# River Oaks Stormwater Capture Project

## File No. ER20-186

Initial Study / Mitigated Negative Declaration

## RESPONSES TO PUBLIC COMMENTS AND TEXT CHANGES

**Figure 2-4: Concept Rendering of Proposed Project**  
(Revised January 2021)

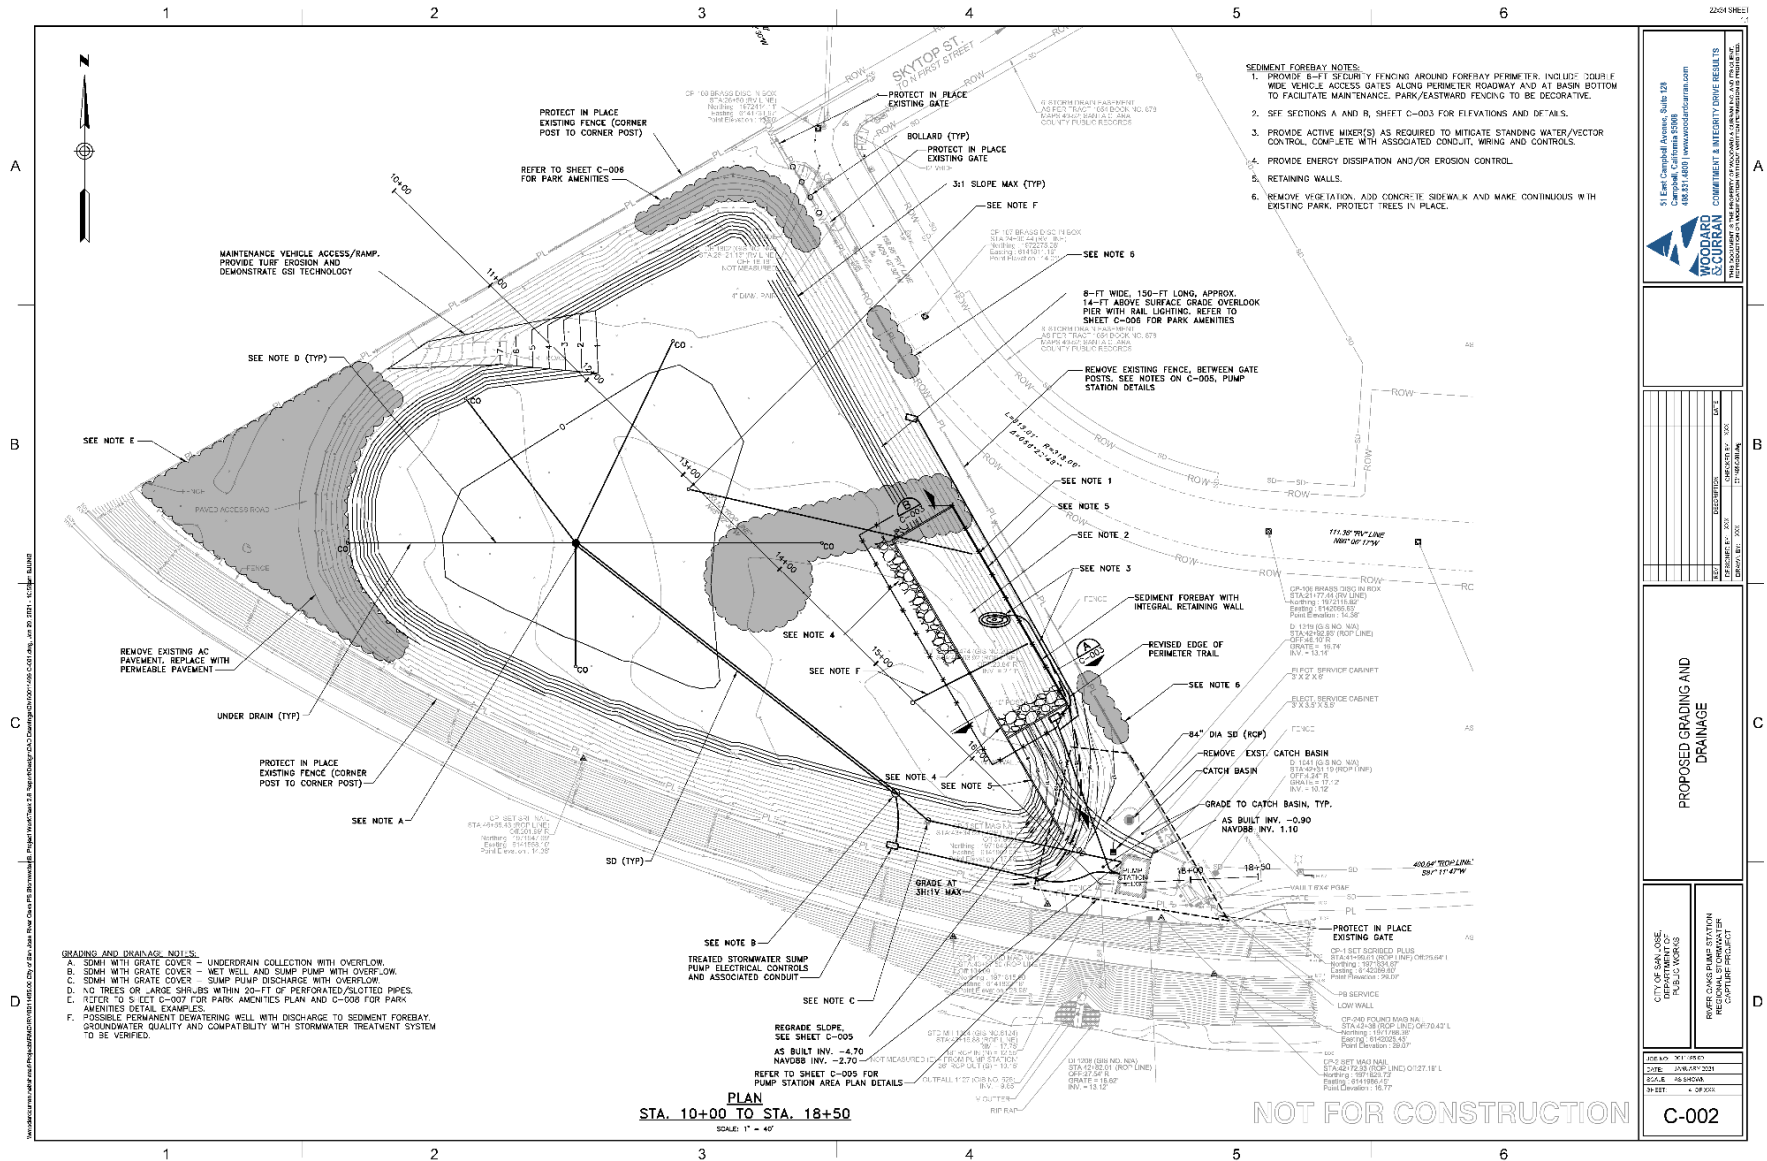
**Comment C2:** The comment states that it is unclear on Figure 2-4 if any of the proposed trees will be within 15 feet of the levee toe. To be in conformance with Army Corps of Engineer Levee Guidelines, all trees should be located at least 15 feet from the toe of the levee.

**Comment C4:** Comment states that while page 2-10 notes that no work is proposed within 15 feet of the levee toe, based on Figures 2-4, 2-5 and 2-6 it appears that grading and planting is proposed to occur up to the toe of the levee and on Valley Water property.

2. It is unclear on Figure 2-4 if any of the proposed trees will be within 15 feet of the levee toe. To be in conformance with Army Corps of Engineer Levee Guidelines, all trees should be located at least 15 feet from the toe of the levee. C2

4. Page 2-10 notes that no work is proposed within 15 feet of the levee toe; however, based on Figures 2-4, 2-5 and 2-6 it appears that grading and planting is proposed to occur up to the toe of the levee and on Valley Water property. C4

**Response C2:** As discussed in the IS/MND project description, none of the proposed trees would be located within 15 feet of the levee toe. As discussed on page 2-10 of the IS/MND, no roots or structural foundations would be allowed to penetrate the levee prism, and the future growth of trees would be anticipated during final design plant selection to avoid growth into the levee prism. The proposed project would conform with Army Corps of Engineers Levee Safety Program. No changes to the IS/MND are needed.

**Response C4:** It is acknowledged that the conceptual rendering appears to reflect improvements within 15 feet of the levee toe, however the conceptual layout will be updated during final design. The existing levee toe, as surveyed, is approximately at the existing fenceline. No improvements are proposed within 15 feet of the levee toe, as shown on Figure 2-5, where only the portion of the existing path on City property would be repaved. Significant consideration has been given to avoiding impacts to the levee throughout the planning stages of the proposed project, as reflected in the IS/MND, and it is intended that project grading and plantings will not impact the levee. These objectives will be reflected in the final design. As noted in Table 2-4 of the IS/MND, the City would obtain a permit for any potential work on Valley Water property, with specific permitting needs to be determined during detailed design. No text changes to the IS/MND are needed.
